## **SOLICITATION AMENDMENT MODIFICATION DE L'INVITATION**

<b>Title - Sujet</b> MARINE CONSTRUCTION EASTERN PASSAGE	
<b>Solicitation No. - N° de l'invitation</b> EB144-142161/A	<b>Amendment No. - N° modif.</b> 001
<b>Client Reference No. - N° de référence du client</b> 20142161	<b>Date</b> 2014-01-27
<b>GETS Reference No. - N° de référence de SEAG</b> PW-\$PWA-110-5052	
<b>File No. - N° de dossier</b> PWA-3-70115 (110)	<b>CCC No./N° CCC - FMS No./N° VME</b>
<b>Solicitation Closes - L'invitation prend fin at - à 02:00 PM on - le 2014-02-04</b>	<b>Time Zone</b> Fuseau horaire Atlantic Standard Time AST
<b>F.O.B. - F.A.B.</b> <b>Plant-Usine:</b> <input type="checkbox"/> <b>Destination:</b> <input checked="" type="checkbox"/> <b>Other-Autre:</b> <input type="checkbox"/>	
<b>Address Enquiries to: - Adresser toutes questions à:</b> Collier (PWA), Susan	<b>Buyer Id - Id de l'acheteur</b> pwa110
<b>Telephone No. - N° de téléphone</b> (902) 496-5350 ( )	<b>FAX No. - N° de FAX</b> (902) 496-5016

Amendment 001 is being issued to answer a question from a contractor and to incorporate the following:

## HANDRAIL CONNECTION DETAIL

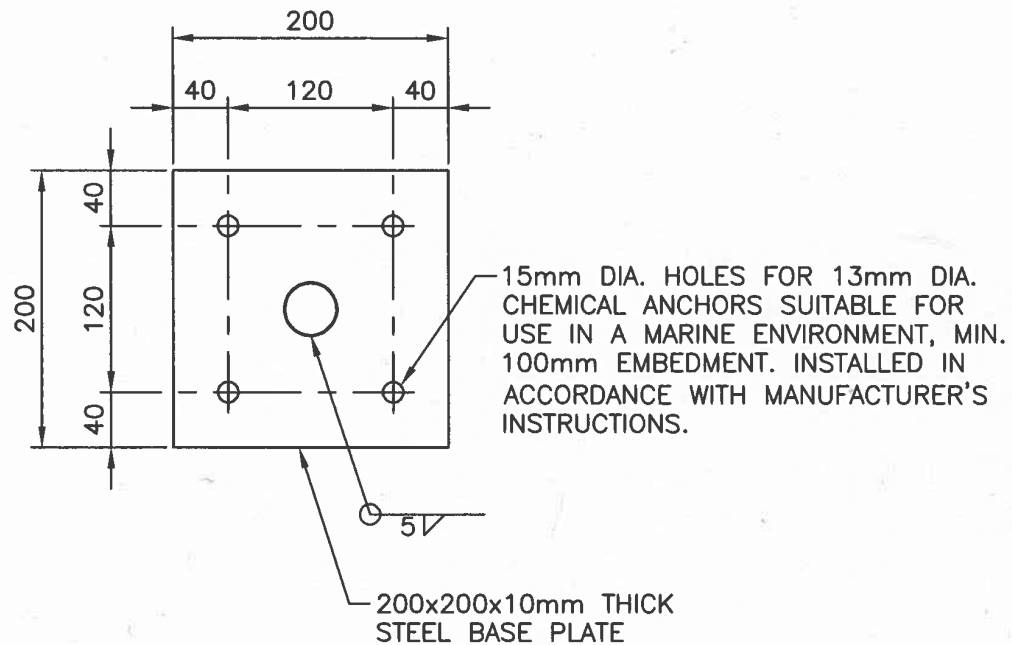
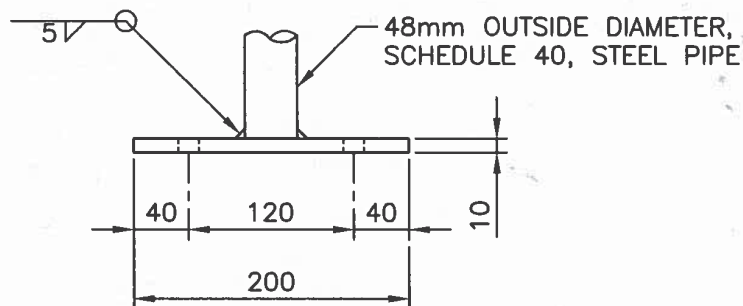
On drawing 2, there is no details/dimensions for the anchoring of the handrail, could you provide more details?

Attached please find drawing detailing handrail connection herein.
